SUBMITTAL SUMMARY REPORT
33138

PLAN NAME: WALMART NEIGHBORHOOD MARKET STORE #3009-1000 **LOCATION:** 9185 SE 165TH MULBERRY LN THE VILLAGES,

OCE: Plan Review (DR) v.1

Sheet No.
C1.3

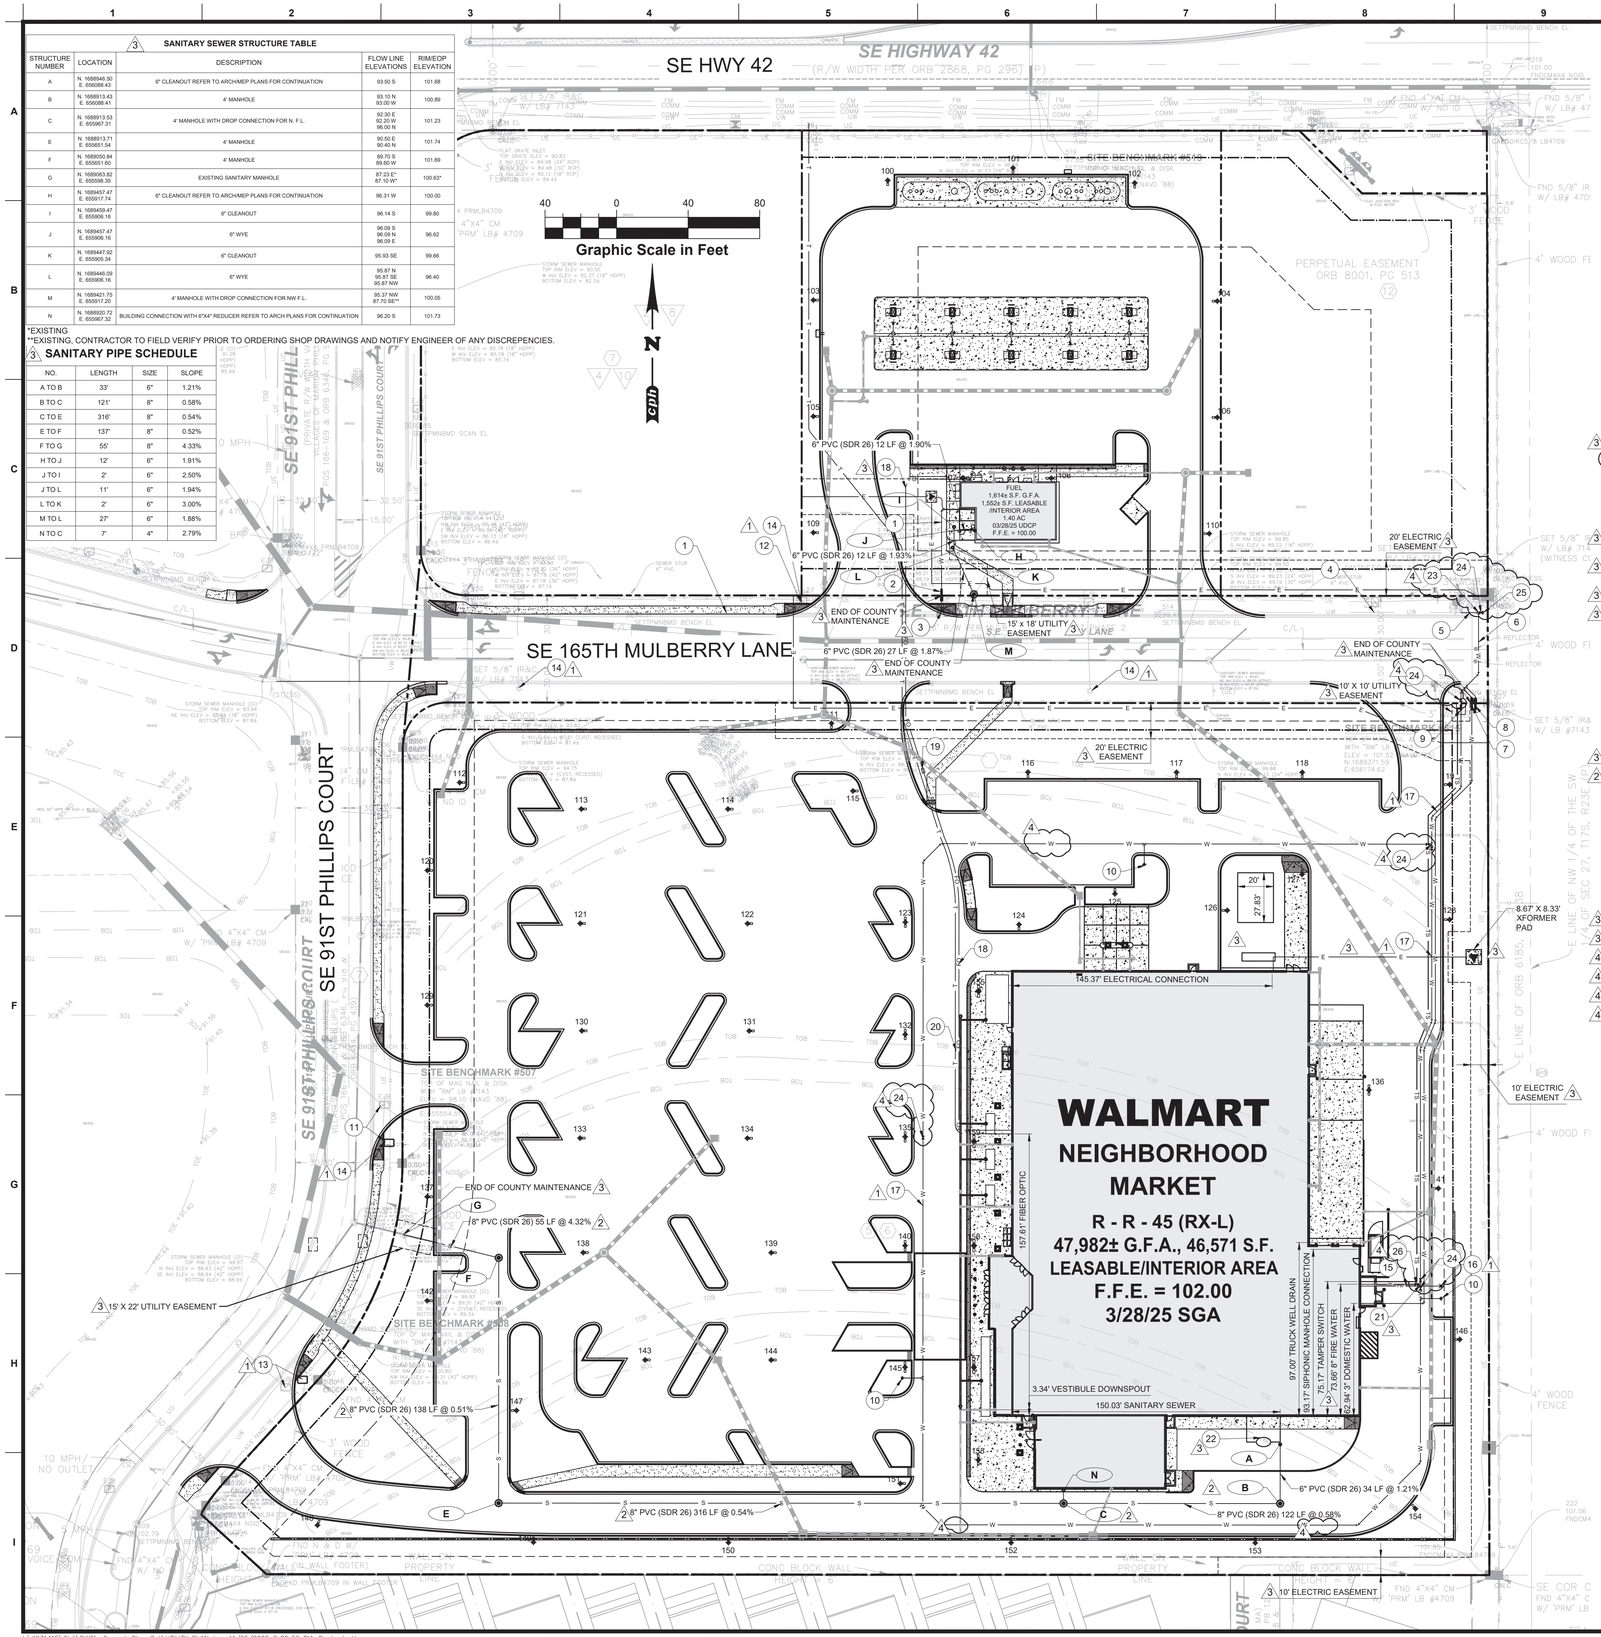
N/A 6.14.2.C.2(e) - Grease Trap, FOG Worksheet 10/29 - Changed to 1000 Gallons. S&S by EOR. Shown on plans and submittal letter. 8/12/25 - C1.3 Maximum grease interceptor size is 1250 per FAC. (2) Grease interceptors calculations will need to be displayed, and signed and sealed by the engineer of record.
N/A 6.14.2.C - Industrial Pretreatment 10/28 Per response letter - No. Service Station will be pre-packaged. 12/25 - C1.3 Is there pre-treatment required for the fuel station? Will they be doing any food preparation, cooking or have any three compartment sinks?
N/A 6.14.3 - Onsite Waste Treatment and Disposal System (OSTDS) - connection requirement on plan
YES 6.14.3.B - Springs Protection Zone 10/28 - Acknowledged. Secondary Springs Protection Zone
YES 6.14.4 - Water (potable) Capital Charges and Flow Rates - proposed use identified to calculate 10/28 - Acknowledged. Capital charges and flow rates will be calculated during the permitting stage, before approval.

YES 6.14.4 - Water (irrigation) Capital Charges and Flow Rates - total irrigated area identified 91,613 SQFT - Shon of C1.3, lower right. Capital charges and flow rates will be calculated during the permitting stage, before approval.
YES 6.14.4 - Sewer Capital Charges and Flow Rates - proposed use identified to calculate 10/28 - Acknowledged. Capital charges and flow rates will be calculated during the permitting stage, before approval.
YES 6.14.5.A(1) - Submittal Requirements - Existing on-site & off-site mains and service connections All shown on plans.
YES 6.14.5.A(2) - Submittal Requirements - Proposed on-site & off-site mains and service connections All shown on plans.
N/A 6.14.5.A(3) - Submittal Requirements - Lift Stations layout, elevations, schedules No private lift station.
YES 6.14.5.A(6) - Submittal Requirements - Manhole locations, rim and invert elevations outside paved areas All shown on plans with measurements.

N/A 6.15.1 - Potable Water Distribution System
N/A 6.15.2 - Decentralized Water System (WTP)
YES 6.15.3 - Fire Protection/Fire Flow Capacity 10/28 acknowledged. Marion County Utilities to provide water. (2) Defer all questions and requirements to Marion County Fire Rescue. (3) C1.3 All Private fire hydrants need to be painted yellow.
N/A 6.15.4 - Water Main Piping Installation
NO 6.15.5 - Water Service and Connection 10/28 Partial Compliance. Need to show tee with gate valve and plug. 8/12/25 - C1.3 - 3 - Move water tap out of asphalt for fuel station . (2) - 5 - Need a T and a valve after the water main connection for Walmart Neighborhood storage.
YES 6.15.6.A - Potable Water Metering - individual/banked, size Shown on plans.
YES 6.15.6.B - Irrigation Water Metering - size 10/28 - 91,613 SQFT. Bubbled on C1.3 on lower right corner, and shown on Irrigation plan sheet. -8/12/25 - C1.3 Total irrigated square foot is needs to be shown on plans.
